Millstone Nuclear Power Station Unit No. 3
Proposed Revision to Technical Specification
Instrumentation Surveillances
(PTSCR 3-30-97)
Marked Up Pages

October 1997

#### MARKUP OF PROPOSED REVISION

**TABLE 3.3-4**

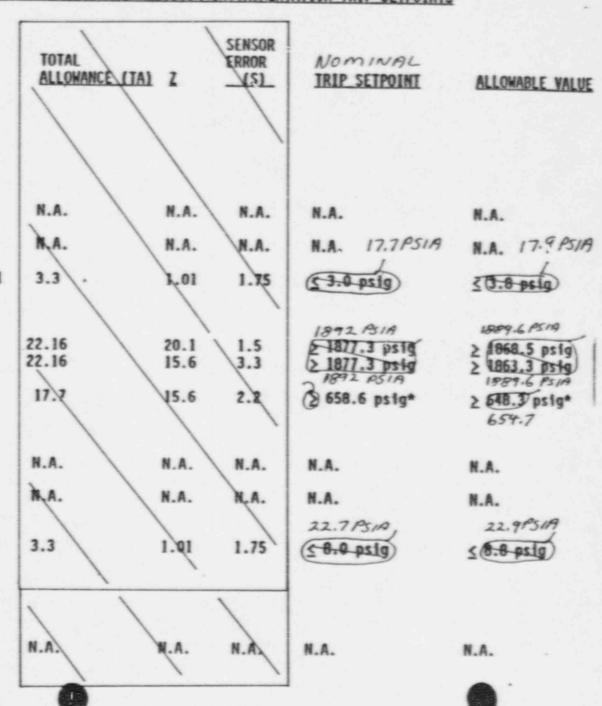
The table is revised to a two column format. The Trip setpoint column becomes a
nominal trip setpoint column. The ESFAS trip setpoints remain unchanged.
Allowable values reflect the analysis of historical instrument data. Editorial changed
have been made to certain Pressure values to reflect expression in PSIA instead of
PSIG and for consistency in significant digits.

tinued	TOTAL ALLOWANCE (TA)	SENSOR ERROR (S)	NOMINAL TRIP SETPOINT	ALLONABLE VALUE	
	N.A.	N.A. N.A.	N.A.	N.A.	
	See Item 1. abo Allowable Value		ty Injection Trip So	etpoints and	
	N.A.	N.A. N.A.	N.A.	H.A.	
	N.A.	N.A. N.A.	N.A.	M.A.	
	3.3	1.01 1.75	\$ 8.0 psige	22.9 FSia-	
	NA ,	N.A N.A.	≤ 1 R/h	≤ 1 R/h	of
	N.A.	N.A. N.A.	N.A.	N.A.	
c	N.A.	M.A. N.A.	N.A.	H.A.	Sa.
gh-2	3.3	1.01 2.75	(3.0 psia	5 (3.8 psig) 5 (54.7	Syre 3/
	17.7	18.6 2.2	2 658.6 psig*	2 48.3 psig*	. 10
	5.0	0.5 0	< 100 psi/s**	s(122.7) ps1/s**	1996
